ULPOWER AERO ENGINES N.V.

SERVICE BULLETIN

Service Bulletin No. 2018-03

SUBJECT: Throttle position sensor

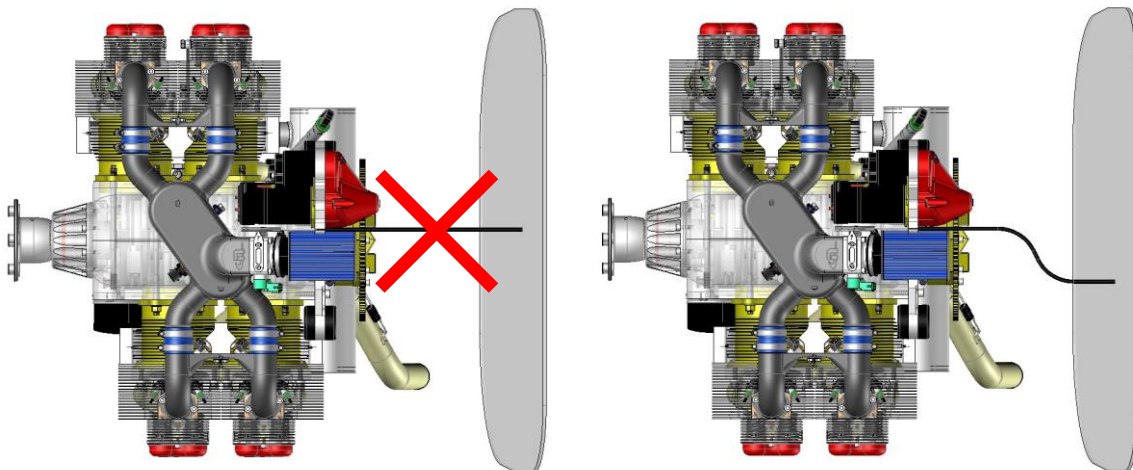
We have noticed early wear of the throttle position sensor (TPS) in aircraft where the throttle cable was not installed in accordance with the official ULPower installation manuals .

When a throttle cable is installed in a straight line from the throttle lever to the fire wall , or when the lever is controlled by a push/pull (or similar) system, engine vibrations create a non-stop movement of the TPS's brushes on the copper lane, resulting in an early wear of the TPS. This may lead to an incorrect signal to the ECU and a possible engine stoppage in flight.

- 1) Check if your throttle cable is installed in accordance with the official ULPower installation manuals

For your convenience we have copied part of the related info from the installation manual below

INCORRECT

CORRECT

If your throttle cable is installed the correct way, no further action is required

If your throttle cable is installed incorrectly, please follow the instructions below

2) Install the throttle cable according to the manuals and replace the throttle body +TPS

A correctly installed throttle cable will help to neutralize engine/propeller vibrations.
